Hills Showground Station Precinct

Response to RFI by Department of
Planning, Industry and Environment

November 2020

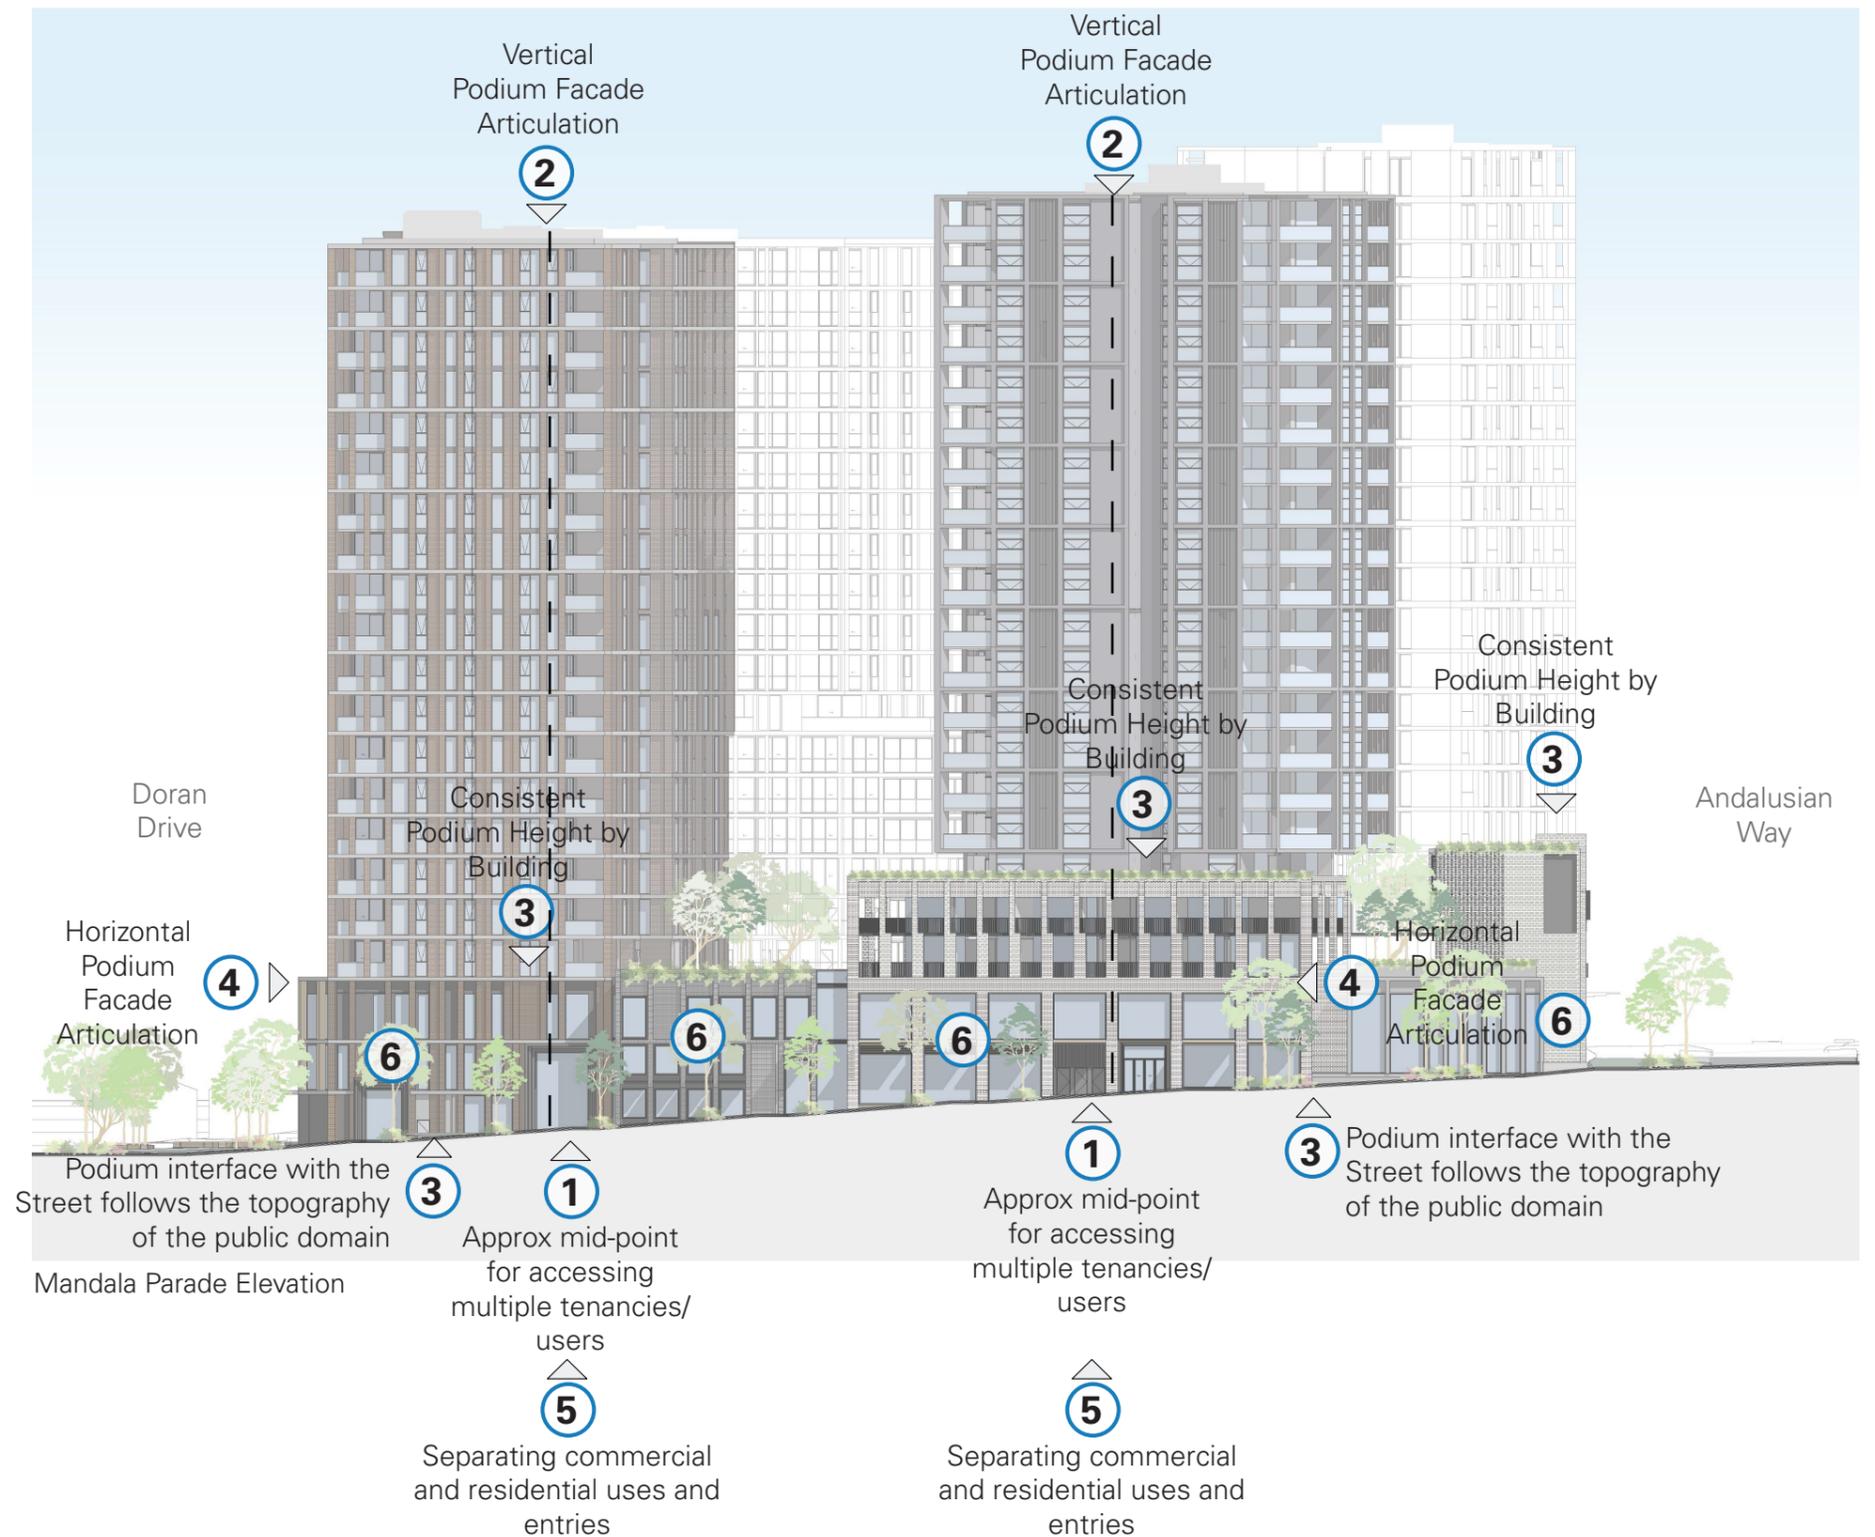
“Further illustrate how future development within the proposed building envelopes would achieve satisfactory urban design outcomes and levels of amenity for the Doran Drive Precinct, particularly in respect to:

- ***the interface between the 4 storey podium fronting Andalusian Way/ Mandala Parade and the angled towers, Buildings G and F***
- ***the transition from a 2 storey to a 4 storey podium along Doran Drive to Andalusian Way.”***

Proposed controls applicable to the Mandala Parade and Andalusian Way interfaces, podiums and towers above.

4.2.4.2

The southern, northern and eastern street walls of the Doran Drive Precinct may be a minimum of 2-storeys high and a maximum of 4-storeys high to allow for variation in the podium in response to topographical conditions on the site and the location of communal open space areas on the podium and potential relationships to the public domain

4.2.5.1.b

3m secondary setback above the podium.

Doran Drive Precinct Massing

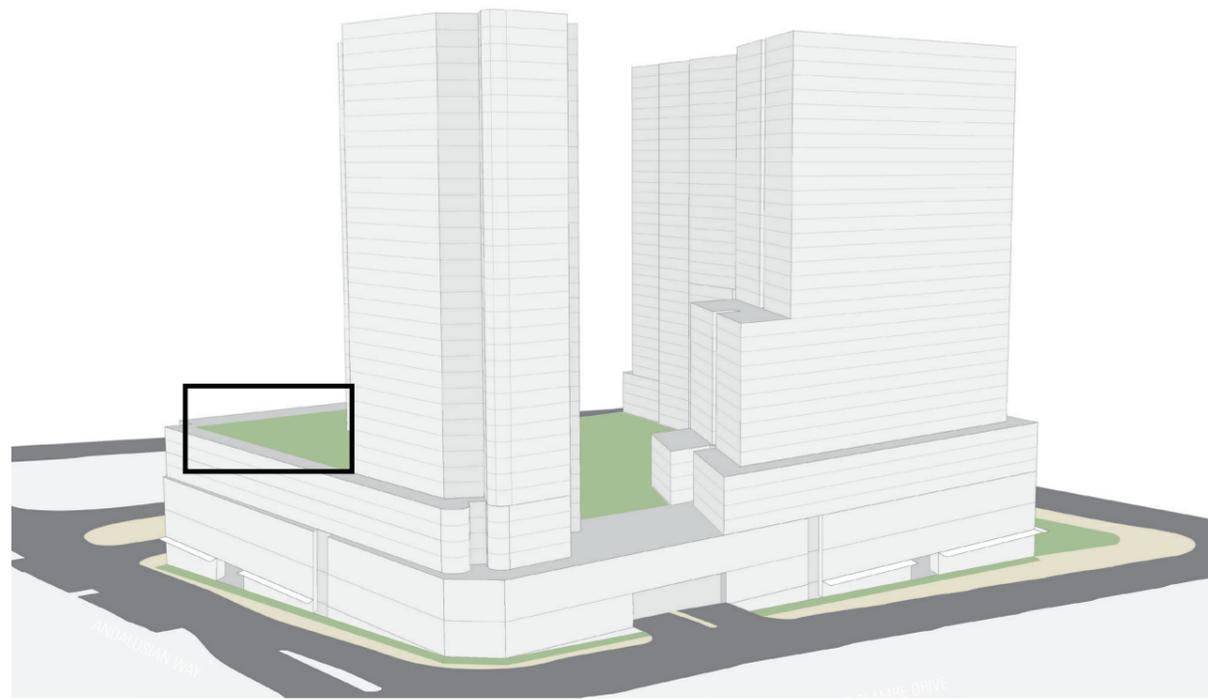
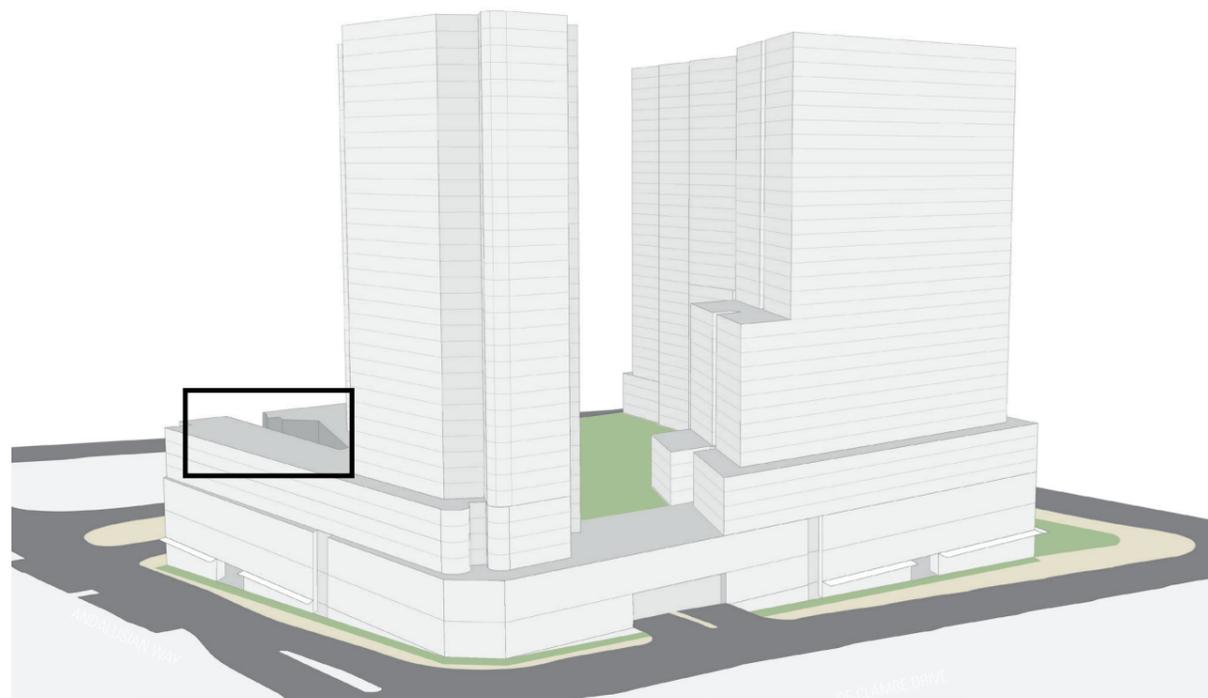
Amendments to Proof of Concept and 3D modelling to align

Figure 206: Potential Single Loaded Townhouse Apartment Layout

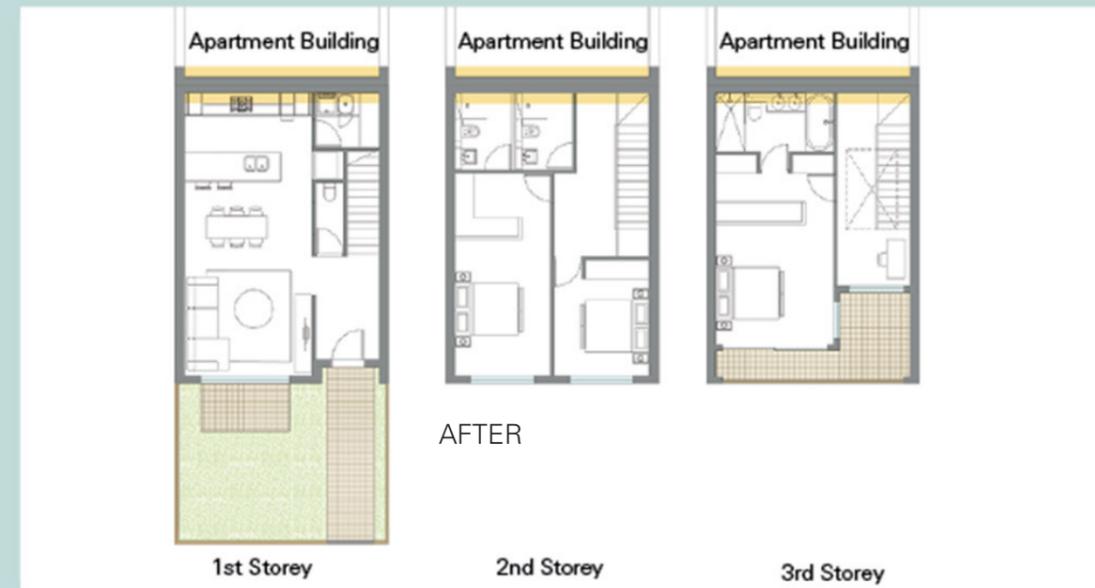
“Demonstrate the building separation distance between the proposed townhouses fronting Andalusian Way and Buildings P & R in Precinct East are sufficient to support good levels of residential amenity..”

Design Guidance

Figure 206 shows how the layout of single loaded townhouse apartments and adjoining apartment buildings can be planned so that openable windows, an upper level terrace and operable roof ventilation can be located so both typologies can be designed together. Figure 207 shows the layout of a double loaded townhouse apartment with openable windows, north facing upper level terrace and a front and rear courtyard.

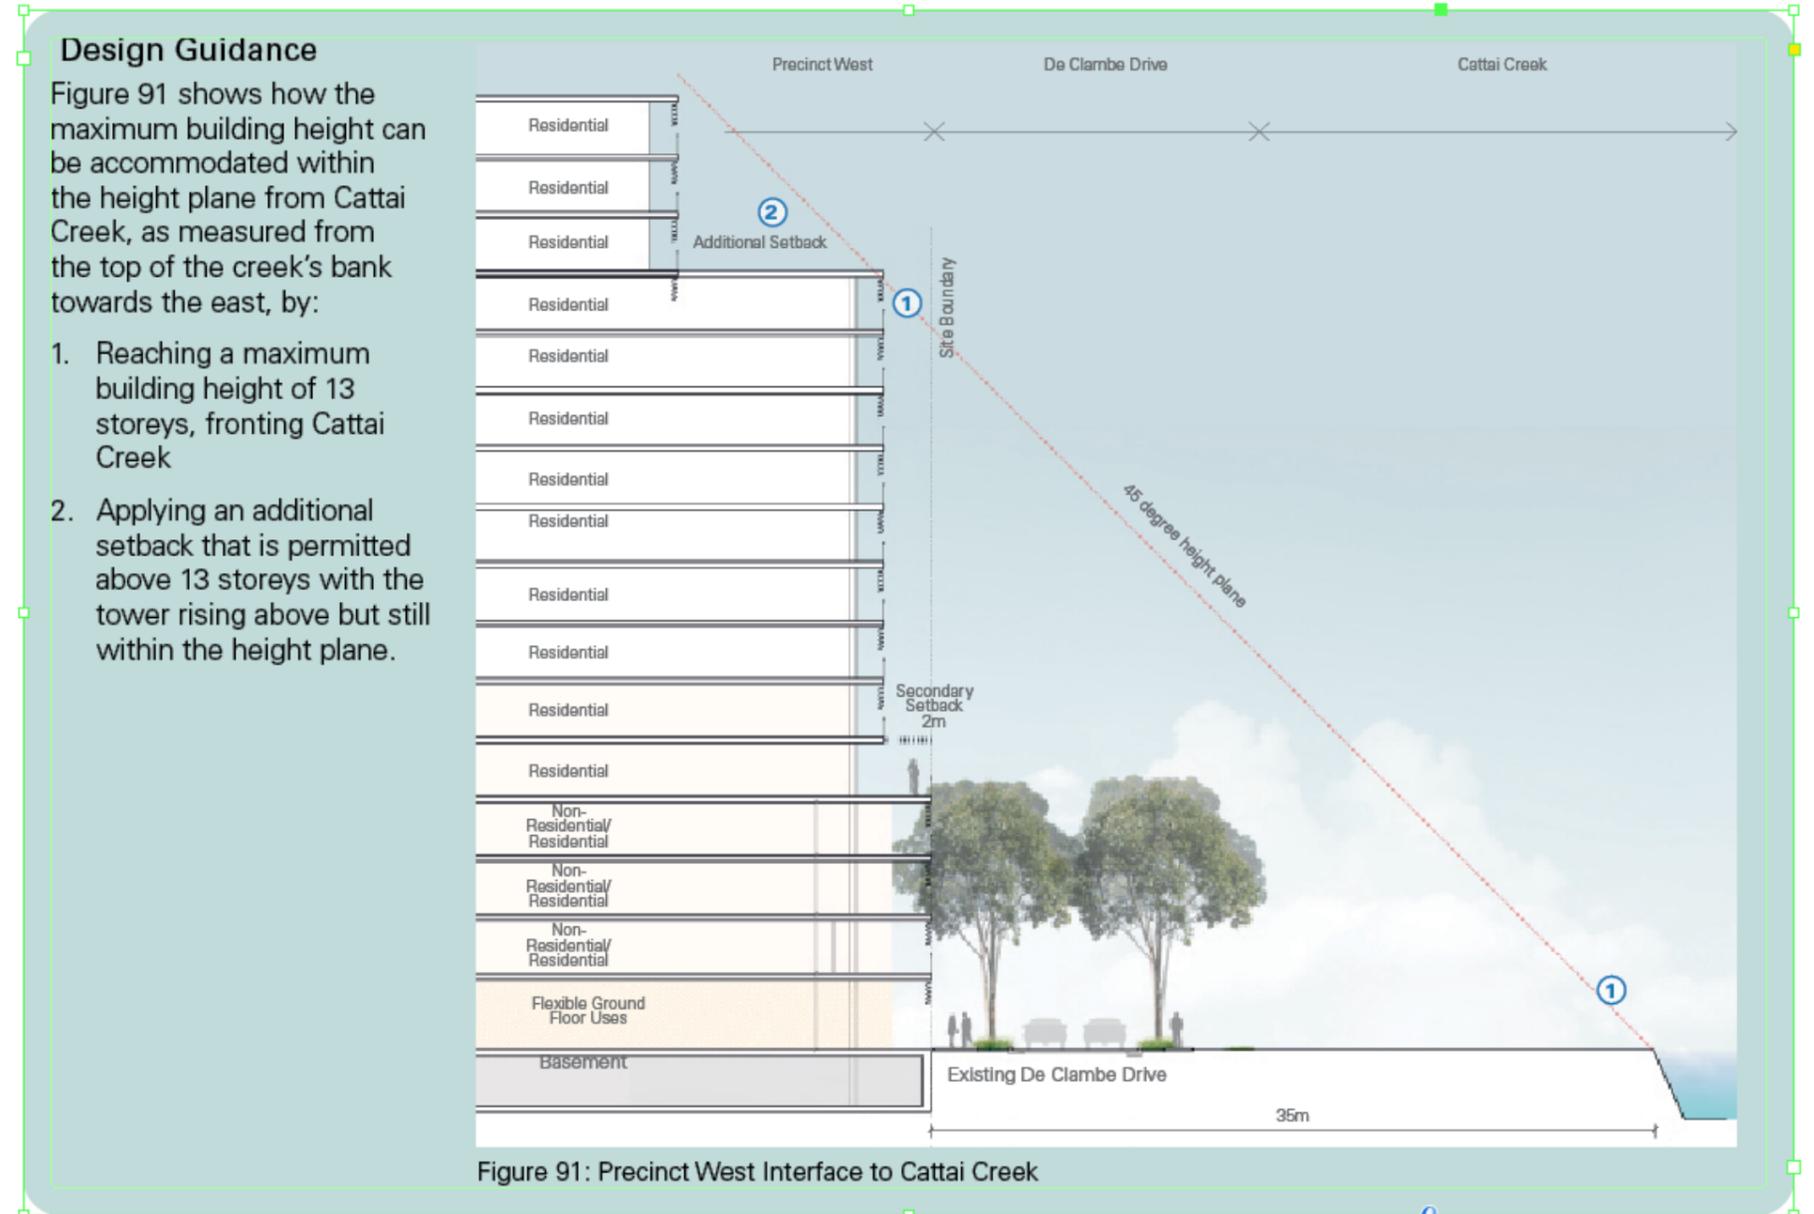
“Clarify the discrepancies between the reference to secondary setbacks in the Design Guidelines and the proposed building envelopes, including any projections such as balconies.”

Balconies and all other projections/external finishes are to be located within the secondary setback.

The diagram adjacent shows the amendments to be made to show balconies within the secondary setback on pages; 126, 127, 128, 129, 161 and 162 in the Hills Showground Station Precinct Urban Design Guidelines.

Precinct West Interface with Cattai Creek

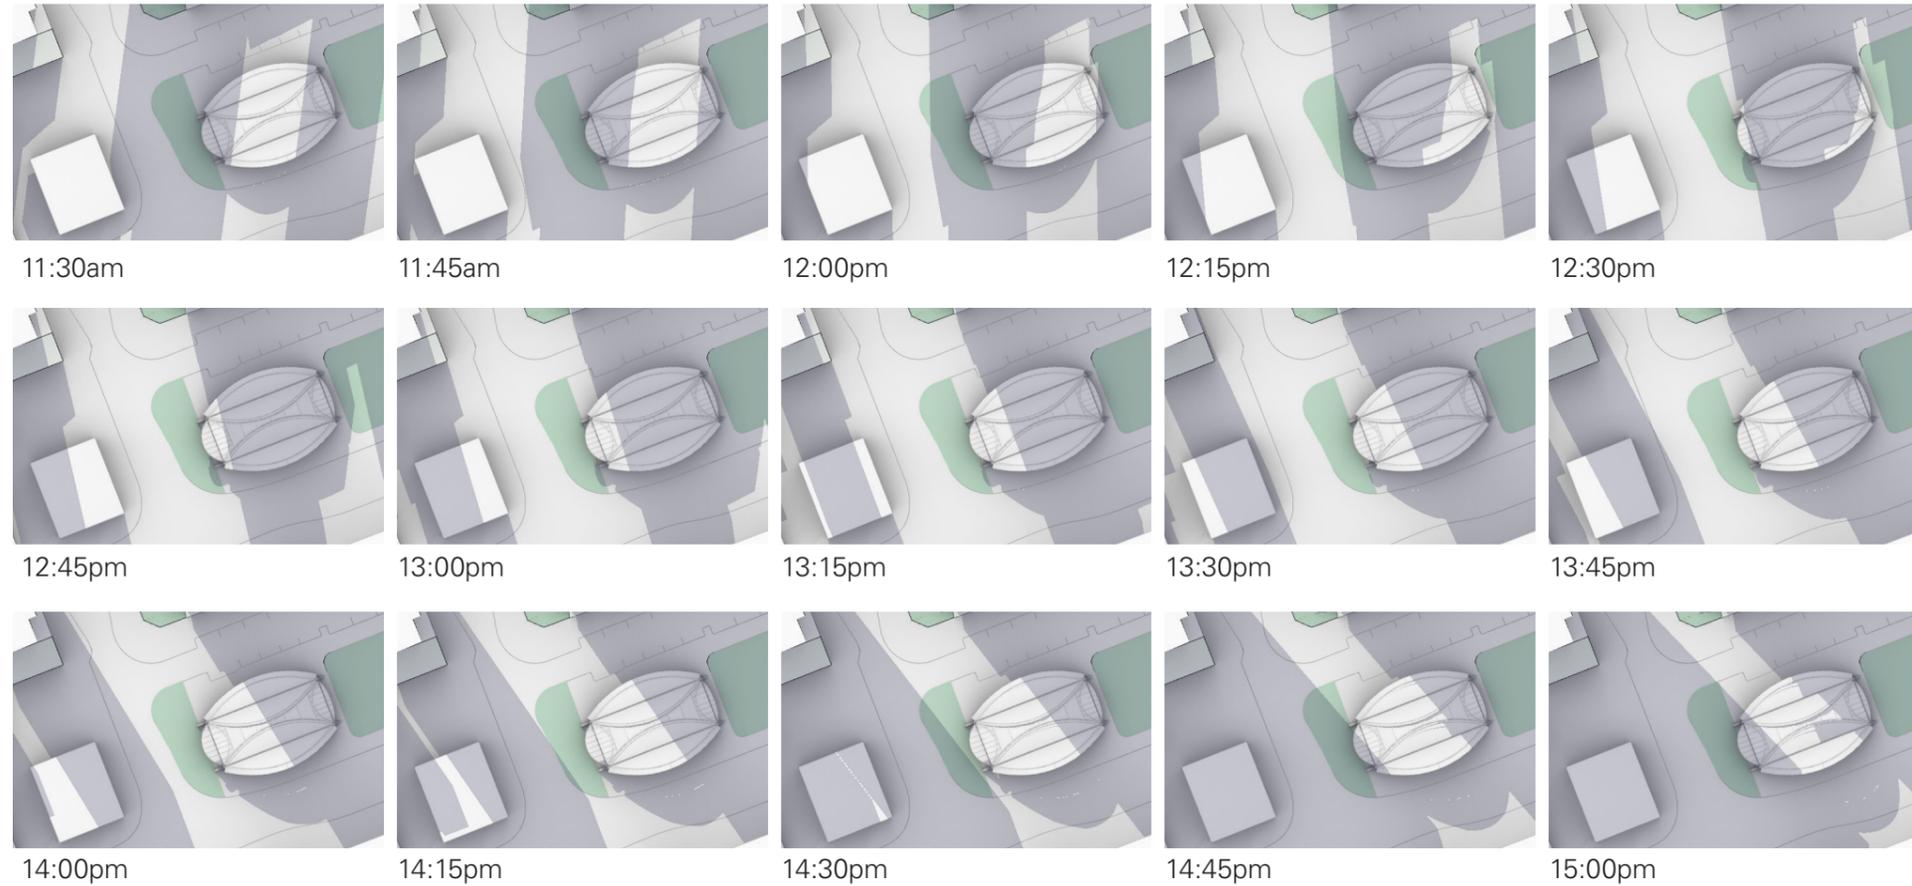
“Confirm where the top of the bank is measured from in Part 3.2.6 Control 1.”

A 35m metric has now replaced the “top of bank” from which the height plane is to be measured.

The 35m is to be measured to the east of the site boundary for Precinct West where it interfaces with De Clambe Drive and the Cattai Creek corridor.

Metro Station Solar Access during Winter Solstice (June 21st)

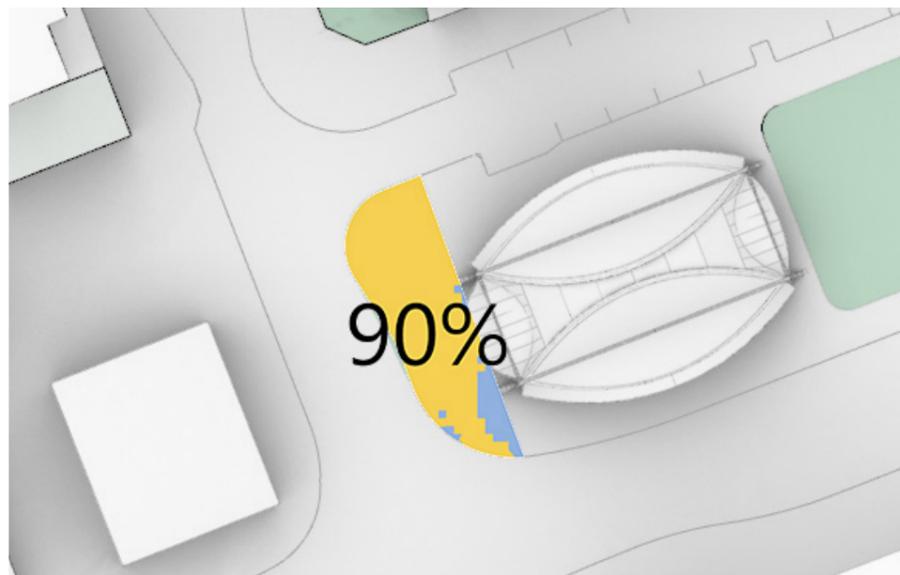
“Illustrate how the open space to the west of the Metro station can achieve the stated 2 hours of solar access to 80% of the open space.”

90% of the station forecourt achieves the minimum 2 hours of solar access between 9am and 3pm during the winter solstice.

The control has been rounded down to 80% to allow for some flexibility in design resolution whilst ensuring high levels of amenity to the station forecourt.

15 minute intervals of the shadow study will be included in the Proof of Concept.
